**Appendix [A] to Applicant's Responses to ExA Written Questions (ExQ1)**

**Appendix [B] To Applicant's Responses to ExA Written Questions (ExQ1)**

**Appendix [F] to Applicant's Responses to ExA Written Questions (ExQ1)**

**Figure ExQ1\_Water supporting Applicant's response to ExQ 1.12.1, 1.12.2 & 1.12.8**

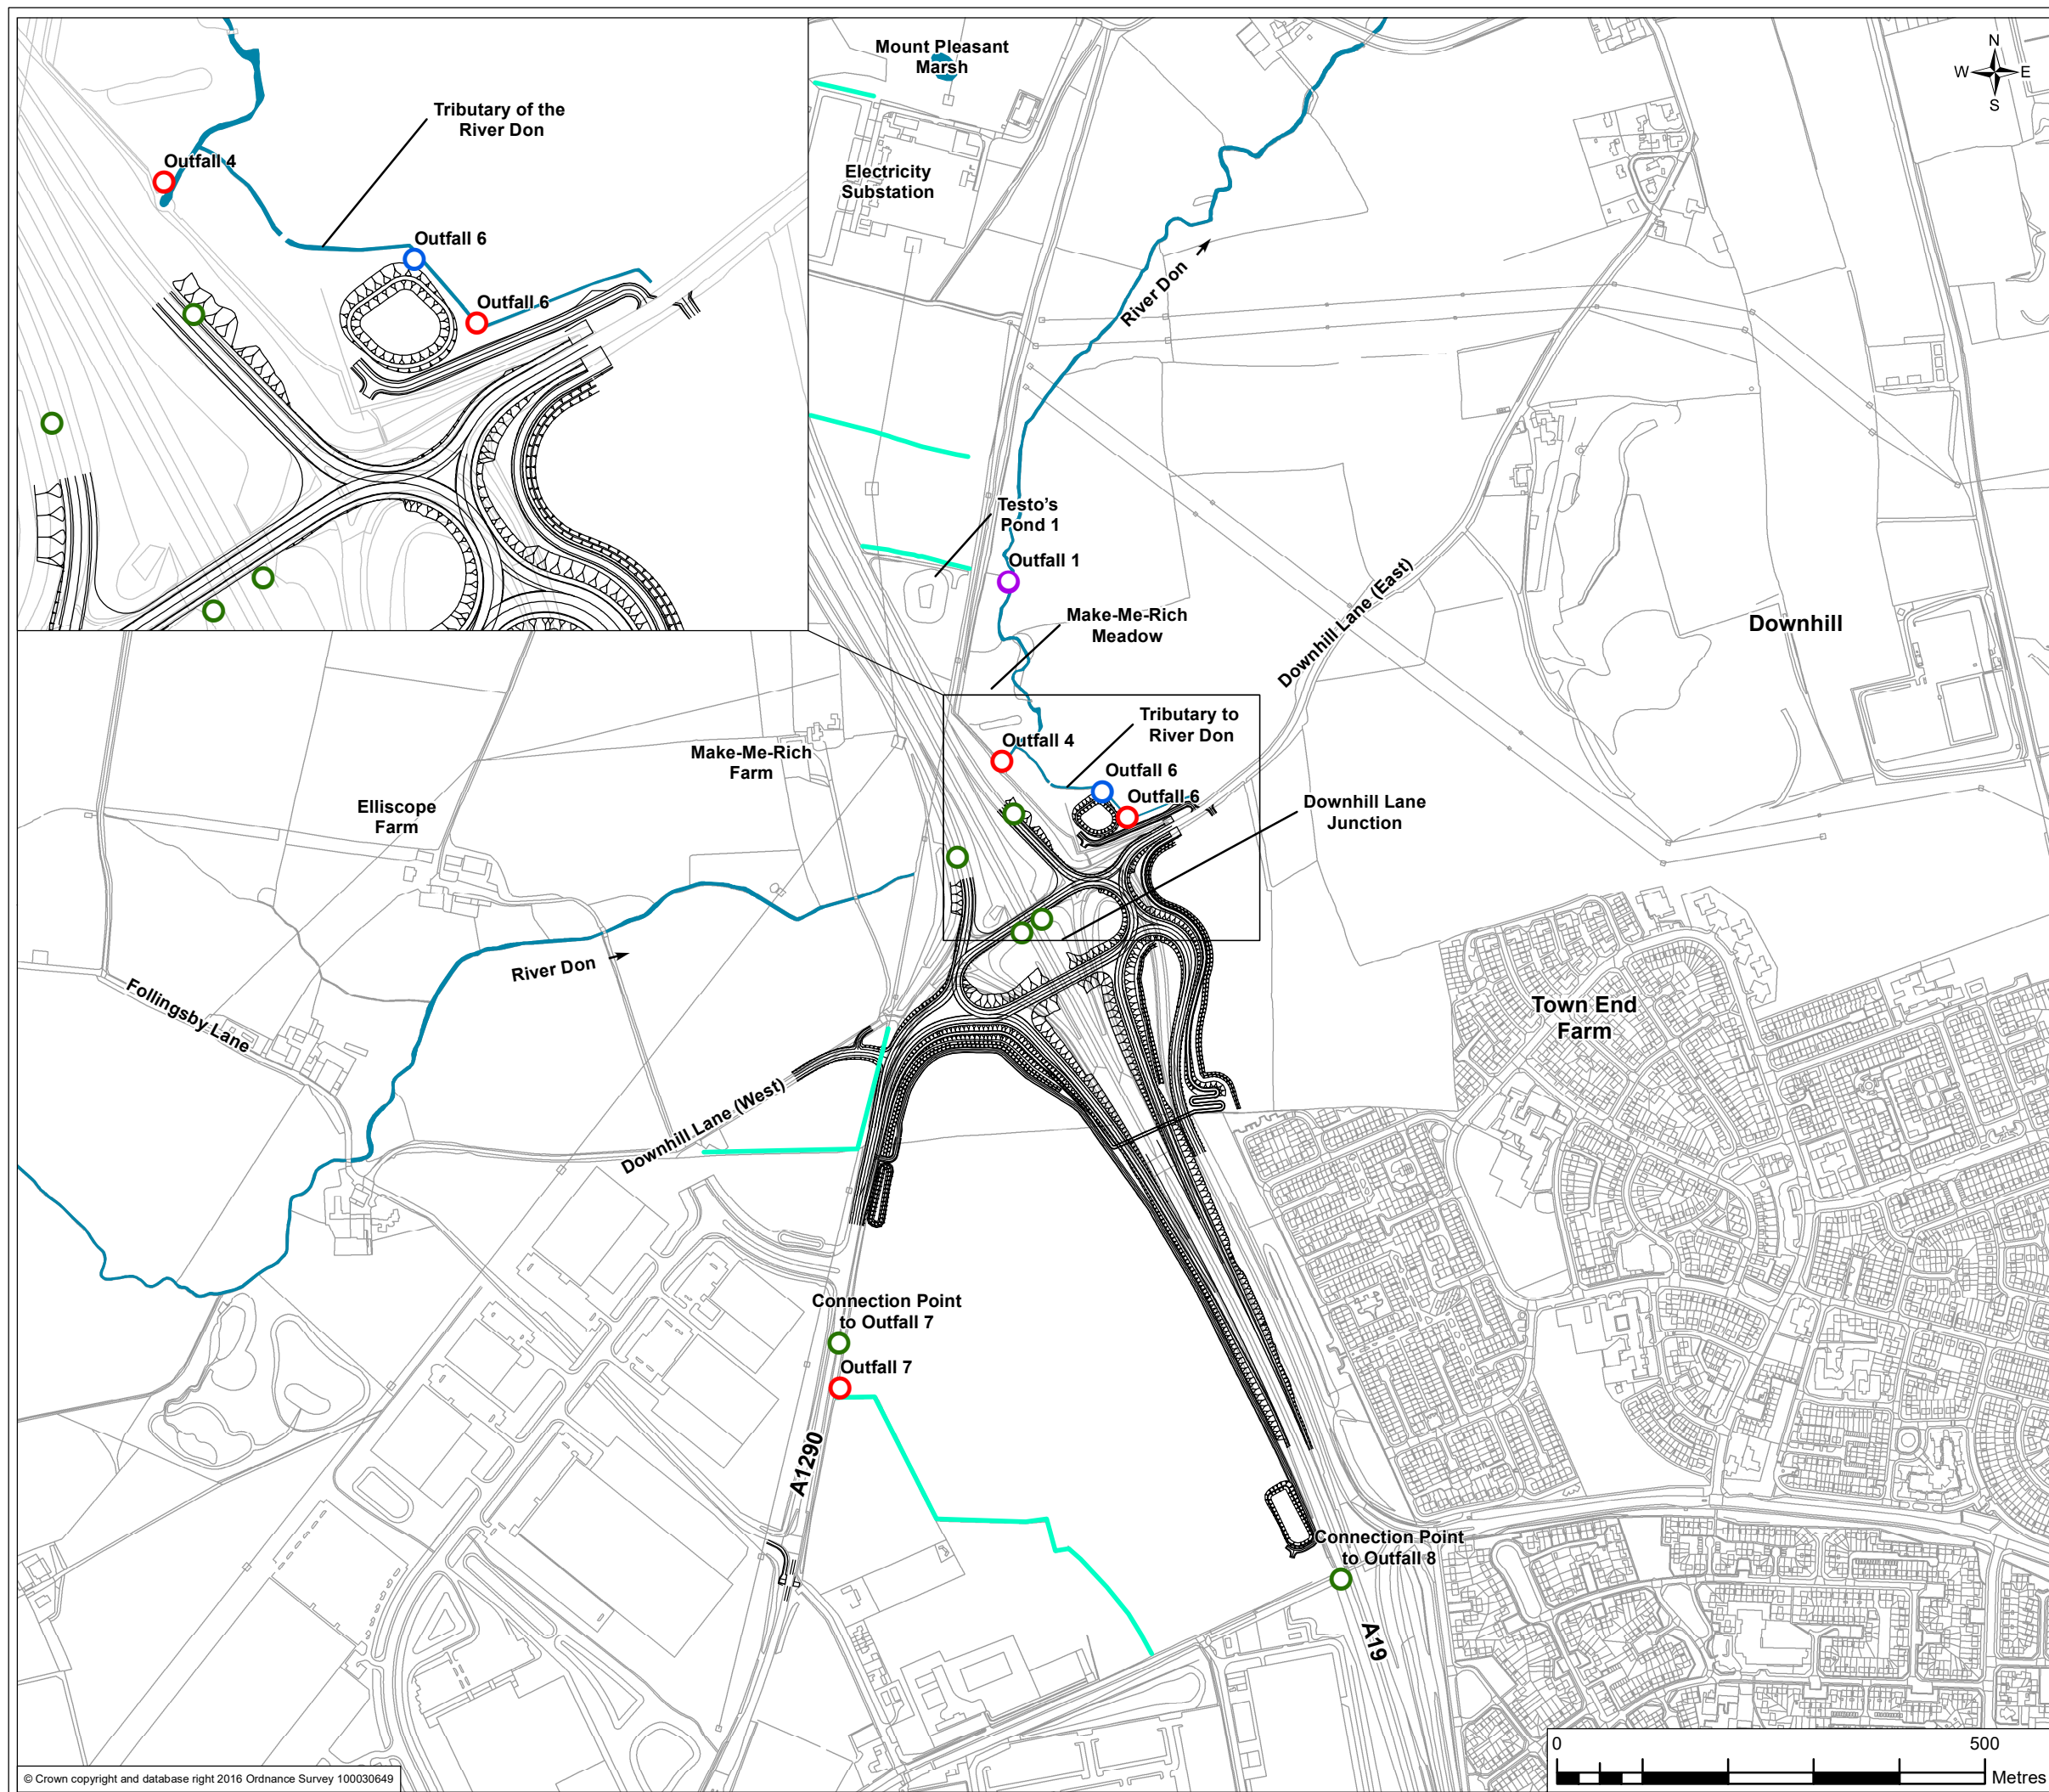
Ref No.	Question:	Response:
12	<b>Water Environment</b>	
Q1.12.1	<p>In paragraphs 2.11.4 of the ES [APP-020] it is stated that the Scheme includes changes to the existing outfall arrangements for two of the catchment areas. One of these, Outfall 4, would be removed as part of the Scheme and the drainage system for this catchment would discharge via Outfall 1 to be constructed as part of the Testo's scheme.</p> <p>The Applicant is asked whether the construction of the drainage system to discharge via Outfall 1 is included as part of the Scheme? If so, please demonstrate how, if not explain how this would meet the requirement for the Scheme to be a standalone project.</p>	<p>The surface water drainage of the Downhill Lane junction and the A19 mainline between the Downhill Lane junction and the Testo's junction is all one catchment, having one outfall (Outfall 1) located within the Testo's scheme. This drainage catchment spans both schemes, having one high point to the north at Testo's junction and another high point to the south at the Downhill Lane junction. The surface water drainage for both the Testo's project and the Downhill Lane project could have been constructed if either scheme was a standalone project by ensuring that the proposed drainage for each scheme could be connected to the existing drainage system.</p> <p>Following the Secretary of State's decision to grant the adjacent Testo's scheme DCO, the work relating to outfalls will be completed as part of the Testo's scheme. The drainage system downstream of the Downhill Lane Scheme, i.e. between the Scheme and Outfall 1, is currently under construction and is therefore not part of the Scheme.</p> <p>As a standalone project, the proposed network 4 drainage ties in to the Testo's drainage within the Scheme limits. Details of the Testo's system and outfalls downstream are provided as these form part of the baseline environment in the ES (<b>Application Document Reference: TR010024/APP/6.1</b>) [APP-020].</p> <p>See Figure ExQ1_Water located in <b>Appendix [F]</b>, prepared specifically for this response, that identifies the location of the proposed Outfall 1 and associated Pond 1.</p>

Q1.12.2	<p>Paragraphs 2.11.5 and 2.11.6 of the ES [APP-020] state that three attenuation ponds are proposed for the Scheme in addition to the attenuation ponds proposed for the Testo's scheme. Pond 1 is described as being constructed as part of the Testo's scheme. Paragraphs 2.11.6-2.11.8 then describe the three attenuation ponds proposed as part of the Downhill Lane Junction project.</p> <p>Is Pond 1, proposed as part of the Testo's scheme, a necessary part of the A19 Downhill Lane Junction Scheme? If it is, please demonstrate how it has been</p>	<p>As explained in the response to Q1.12.1, Network 4 is part of a larger drainage catchment, including the A19 mainline between the Testo's junction and the Downhill Lane junction. As the Testo's DCO has been granted and the scheme is under construction, all assessments of the drainage system were made on the basis that the Network 4 drainage would tie in to the Testo's drainage system and that the Testo's drainage system, including ponds and outfalls, forms part of the baseline environment.</p>

Ref No.	Question:	Response:
	<p>assessed, how it it's construction would be authorised through the DCO and show in plan form how it relates to the Downhill Lane Junction Scheme? If it does not relate to the Scheme, please clarify the relationship between Pond 1 and drainage for the Downhill Lane Junction Scheme.</p>	<p>Pond 1 is a necessary part of the A19 Downhill Lane Junction Scheme.</p> <p>Pond 1 and the associated Outfall 1 referred to in paragraphs 2.11.5 and 2.11.6 of the ES (<b>Application Document Reference: TR010024/APP/6.1</b>) [APP-020] were assessed as part of the Testo's scheme and are currently under construction as part of the Testo's scheme. For the Downhill Lane Junction Scheme, the assessment was based on the Testo's pre-construction design of the pond. It was found that the pond size was adequate when assessed with the additional runoff from the Downhill Lane scheme albeit with minor changes in predicted water levels and discharge rates all within limits agreed with the Lead Local Flood Authority, South Tyneside Council.</p> <p>See Figure ExQ1_Water located in <b>Appendix [F]</b> that identifies the location of the proposed Outfall 1 and associated Pond 1. Please note, that Pond 1 is labelled "Testo's Pond 1" on this drawing.</p>
